Appendix II

Confirmatory Debris Generation Analyses

Figure II-12. Calcium Silicate Damage Curve for Small Fine Debris

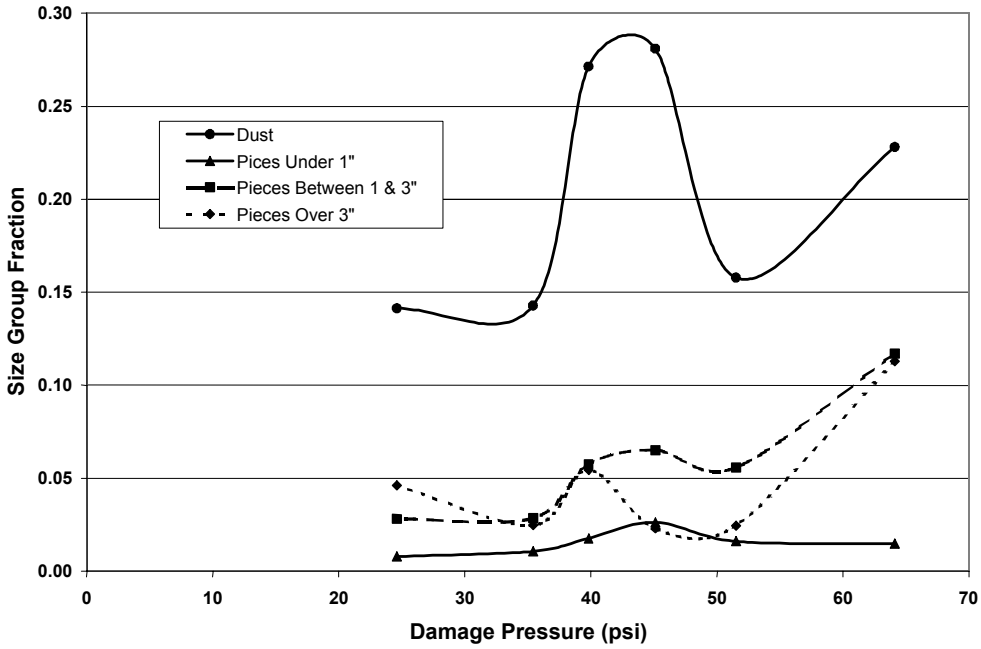
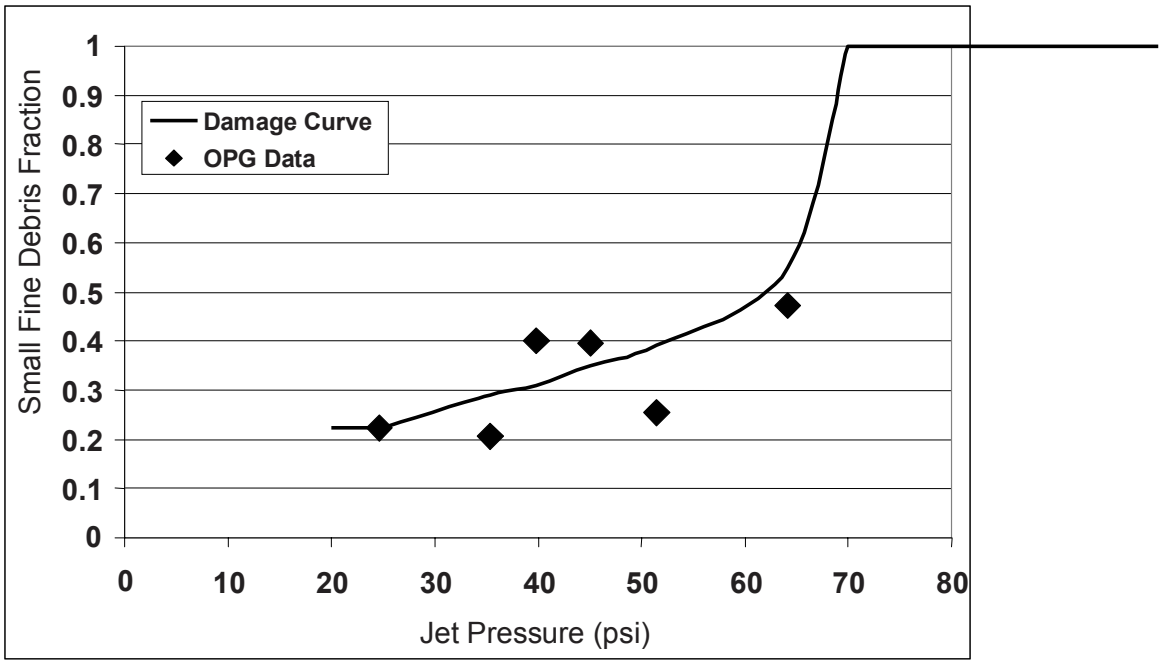
The NEI baseline guidance recommends the assumption that 100 percent of the calcium silicate insulation located inside a ZOI defined by the destruction pressure of 24 psi (corresponding to a radius of 5.5/D) becomes small fine debris. The OPG debris generation tests (N-REP-34320-10000-R00) were cited to justify the 24-psi destruction pressure. The OPG tests involved impacting aluminum-jacketed calcium silicate insulation targets with a two-phase water/steam jet. The jacketing was secured with stainless-steel bands, and the jacketing seams were typically oriented at 45 degrees from the jet centerline—an orientation that appeared to maximize damage. The OPG data, illustrated in Figure II-11, only cover a limited range of damage pressures (approximately 24 to 65 psi).

The damage curve shown in Figure II-12 was generated by summing all four debris categories in Figure II-11 to obtain the OPG debris fractions shown and then constructing a plausible curve through the data that was conservatively extrapolated at both ends. Table II-9 provides the results of the calcium silicate debris-size distribution integration over the ZOI. Figure II-13 compares the potential debris volumes and provides an estimate using the baseline guidance (100 percent of $4\pi/3\ (5.45/D)^3$). A lower alternate damage pressure results in a larger equivalent spherical ZOI, but a lesser fraction of the debris is damaged into small fine debris. The use of the alternate damage pressures over the NEI-recommended damage pressures for PWR analyses would result in approximately 43 percent more estimated small fine debris. For calcium silicate insulation, the baseline is conservative with respect to both the NEI guidance damage pressure of 24 psi and the alternate pressure of 20 psi.
